TO: All U.S. Ford and Lincoln Dealers
**SUBJECT: NEW VEHICLE DEMONSTRATION / DELIVERY HOLD -
 Safety Recall 19S32**
 Certain 2020 Model Year Explorer and Police Interceptor Utility Vehicles
 with a 2.3L or 3.3L Gas Engine
 Potential Wire Harness Contact to A/C Pulley

CERTAIN 2020 MODEL YEAR EXPLORER AND POLICE INTERCEPTOR UTILITY VEHICLES WITH A 2.3L OR 3.3L GAS ENGINE

FIGURE 1

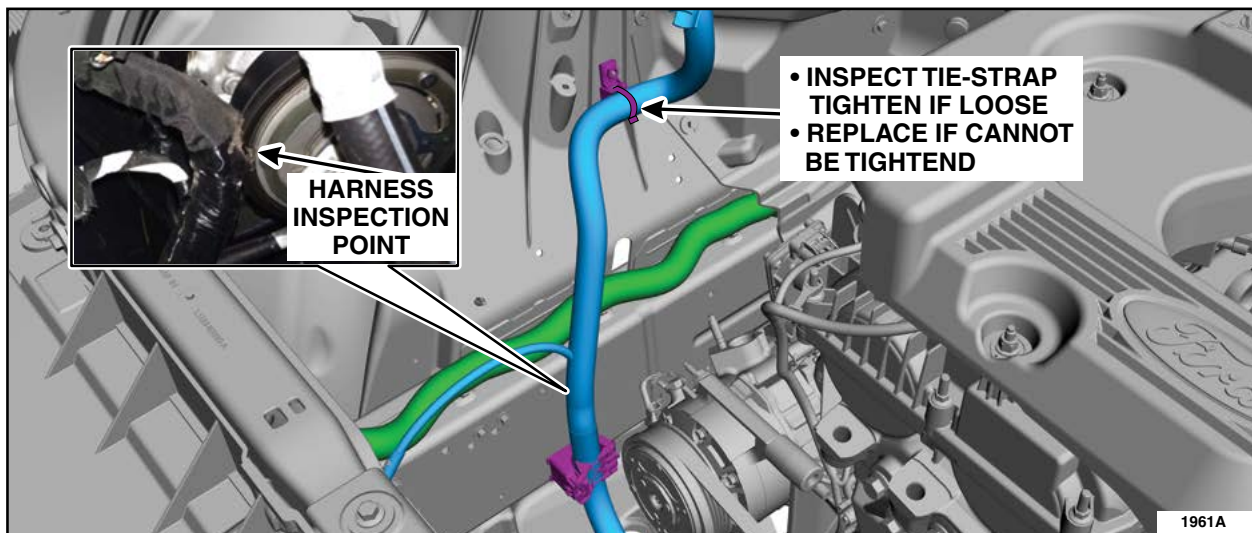
1. Inspect the battery positive cable wire harness in the areas shown for damaged and exposed wire. See Figure 1.
 - Replace the wire harness if any of the larger circuits (2/4/6 awg) have exposed copper wire strands.
 - Repair any damaged (smaller gauge) circuits in the wire harness that have exposed copper wire strands. Please follow the recommended splicing method contained in the wire diagrams section of the Workshop Manual (WSM).
2. Inspect the tie-strap located on the passenger side strut tower. Tighten the tie-strap to properly retain the harness. See Figure 1.
 - Replace the tie-strap if it cannot be tightened fully.

FIGURE 2

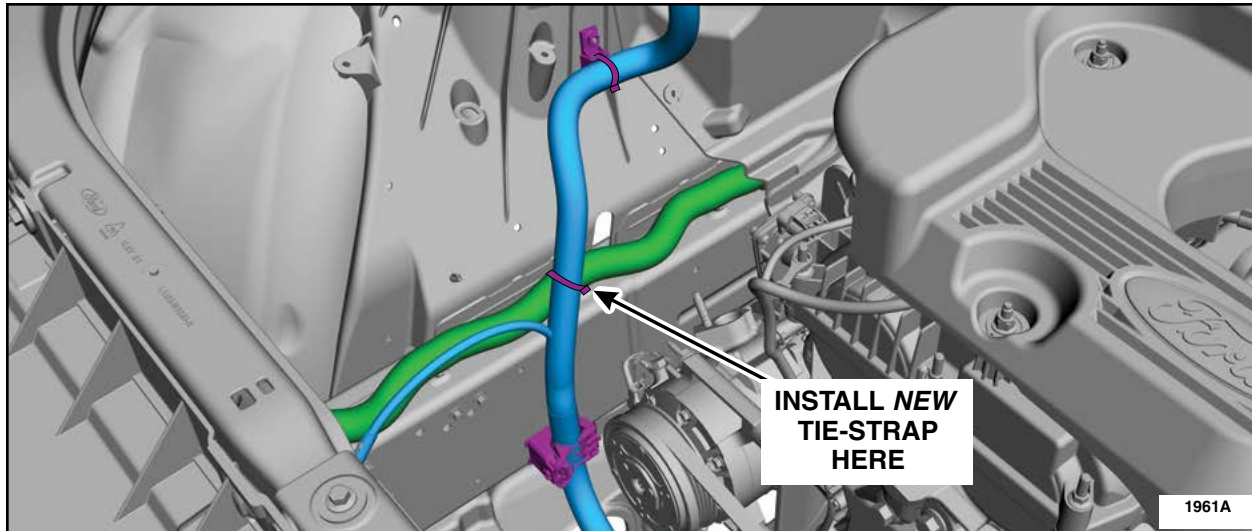
3. If damage to the battery positive cable wire harness was present, the Air Conditioning (A/C) compressor belt must be replaced. Please follow the WSM procedures in Section 303-05A for 2.3L engines or 303-05C for 3.3L engines.
4. Install a tie strap securing the battery positive cable wire harness to the engine wire harness. See Figure 2.
